FDOT INDEX #200/201 UD INSPECTION MANHOLE # 968+00 L ~~966+0L~~

FDOT 434986-1-52-01

STRAIGHT AHEAD CONSTRUCTION

FORTERRA | PIPE & PRECAST

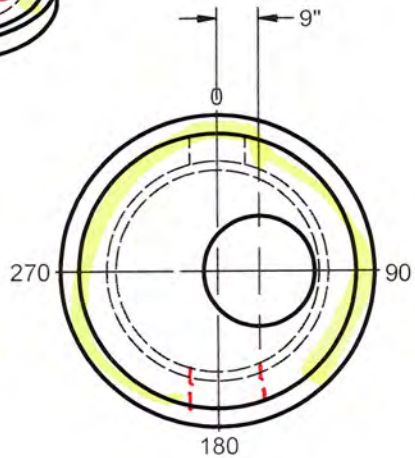
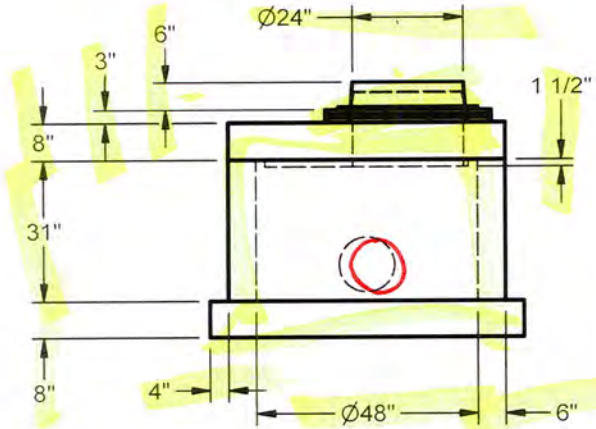
CONTRACTOR'S OPTION TO USE MANHOLE TYPE P ALT. A BASED ON INDEX 245, GENERAL NOTE #5.

VERIFY PIPE SIZE & INVERT

PC #	WEIGHT	PIECE DESCRIPTION	PRODUCT CODE
	CONTRACTOR TO FIELD VERIFY EXIST. 36" RCP INVERT AT EDGEDRAIN TIE-IN TO VERIFY POSITIVE DRAINAGE, PRIOR TO ORDERING STRUCTURE.		
2	1788	048Dia x 06Wall x 08H,024Dia Ecc, TopSlab	SR048S06M008C
1	5202	048Dia x 06Wall x 031H, MonoBaseExt	SR048B06M036X

PC #	DEG/ DIR	PIPE SIZE	PIPE INVERT	HOLE SIZE	BOOT TYPE	HOLE INVERT	HOLE RAISE
1	0	4 ~~6~~ PVC	165.02	10 ~~12~~	NONE	164.77	2"
	180	4"	165.02	10		164.77	2"

FDOT INDEX #200/201 UD INSPECTION MANHOLE # ~~966+00R~~ 968+00 R

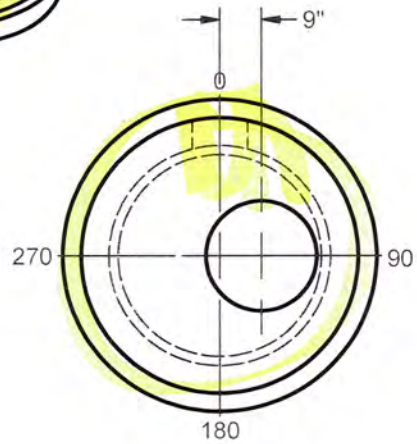
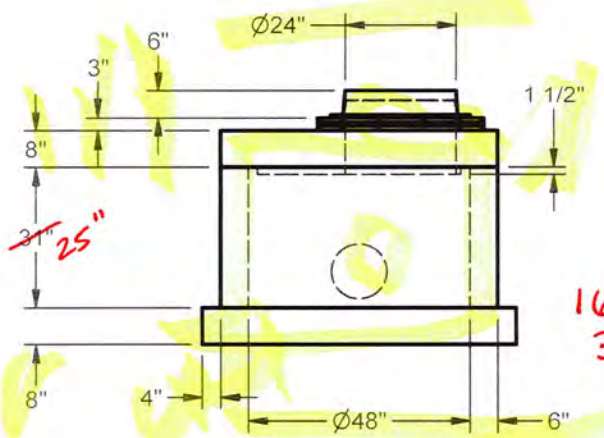
CONTRACTOR'S OPTION TO USE MANHOLE TYPE P ALT. A BASED ON INDEX 245, GENERAL NOTE #5.

FG =	168.60
TA =	168.10
TTS =	167.85
TPW1 =	167.19
ITB =	~~164.60~~ 165.10
APTB =	~~3.50~~ 3.00

PC #	WEIGHT	PIECE DESCRIPTION	PRODUCT CODE
	SEE NOTE ON PLANS. NOT FOR OUTFALL PURPOSES SLOPE PIPE TOWARD ROADWAY		
2	1788	048Dia x 06Wall x 08H,024Dia Ecc, TopSlab	SR048S06M008N
1	5202	048Dia x 06Wall x 031H, MonoBaseExt	SR048B06M036X

PC #	DEG/ DIR	PIPE SIZE	PIPE INVERT	HOLE SIZE	BOOT TYPE	HOLE INVERT	HOLE RAISE
1	0	4" ~~8~~ PVC	~~165.02~~ 165.52	~~12~~ 10	NONE	~~164.77~~ 165.27	2"

FDOT INDEX #200/201 UD INSPECTION MANHOLE # 966+20 L

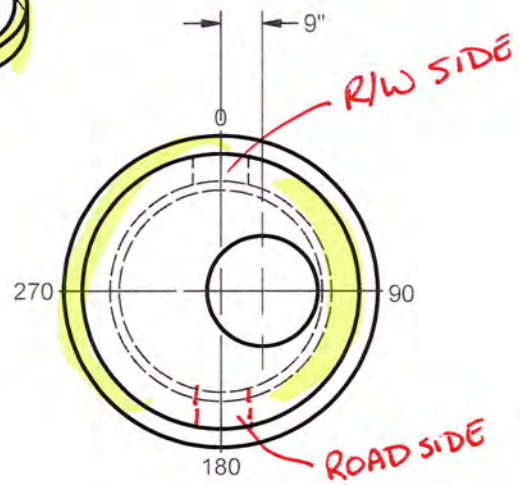
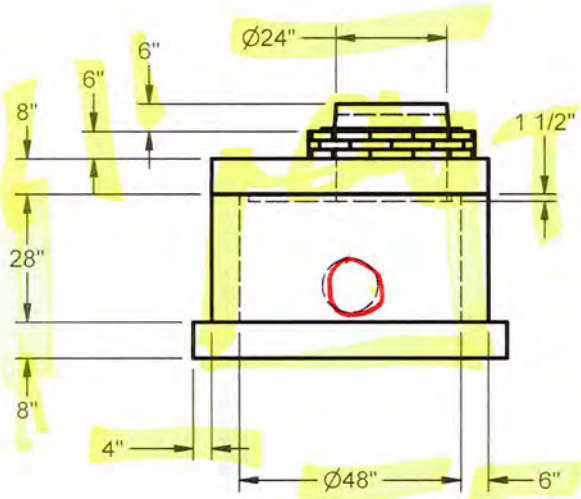
CONTRACTOR'S OPTION TO USE MANHOLE TYPE PALT. A BASED ON INDEX 245, GENERAL NOTE #5.

PC #	WEIGHT	PIECE DESCRIPTION	PRODUCT CODE
	CONTRACTOR TO FIELD VERIFY EXIST. 36" RCP INVERT AT EDGE DRAIN TIE-IN TO VERIFY POSITIVE DRAINAGE PRIOR TO ORDERING STRUCTURE.		
2	1788	048Dia x 06Wall x 08H,024Dia Ecc, TopSlab	SR048S06M008N
1	4937	048Dia x 06Wall x 028H, MonoBaseExt	SR048B06M030X

PC #	DEG/ DIR	PIPE SIZE	PIPE INVERT	HOLE SIZE	BOOT TYPE	HOLE INVERT	HOLE RAISE
1	0	~~6~~ 4" PVC	~~161.52~~ OK	~~12~~ 10	NONE	~~161.27~~ OK	2"
	180	4"	161.62	10	–	161.27	2"

FDOT INDEX #200/201 UD INSPECTION MANHOLE # 973+00 L

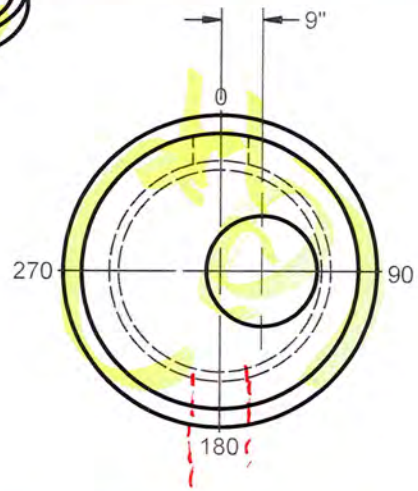
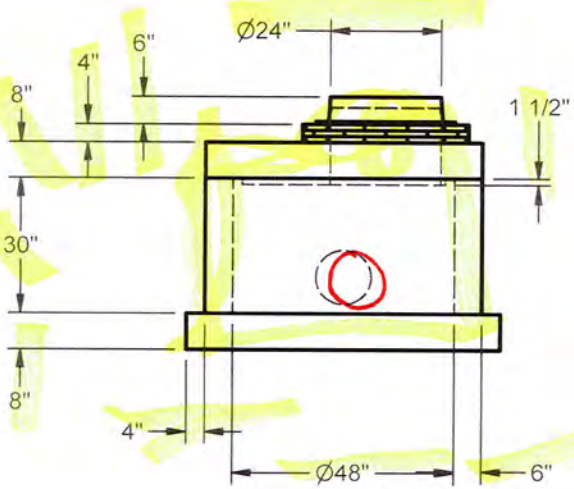
CONTRACTOR'S OPTION TO USE MANHOLE TYPE ALT. A. BASED ON INDEX 215, GENERAL NOTE #5.

PC #	WEIGHT	PIECE DESCRIPTION	PRODUCT CODE
		CONTRACTOR TO FIELD VERIFY EXIST. 36" RCP ~~PIPE~~ INVERT AT EDGE DRAIN TIE-IN TO VERIFY POSITIVE DRAINAGE PRIOR TO ORDERING STRUCTURE	
2	1788	048Dia x 06Wall x 08H,024Dia Ecc, TopSlab	SR048S06M008X
1	5113	048Dia x 06Wall x 030H, MonoBaseExt	SR048B06M030X

PC #	DEG/ DIR	PIPE SIZE	PIPE INVERT	HOLE SIZE	BOOT TYPE	HOLE INVERT	HOLE RAISE
1	0	4" ~~8~~ PVC	167.02	~~12~~ 10	NONE	166.77	2"
	180	4"	167.02	10	–	166.77	2"
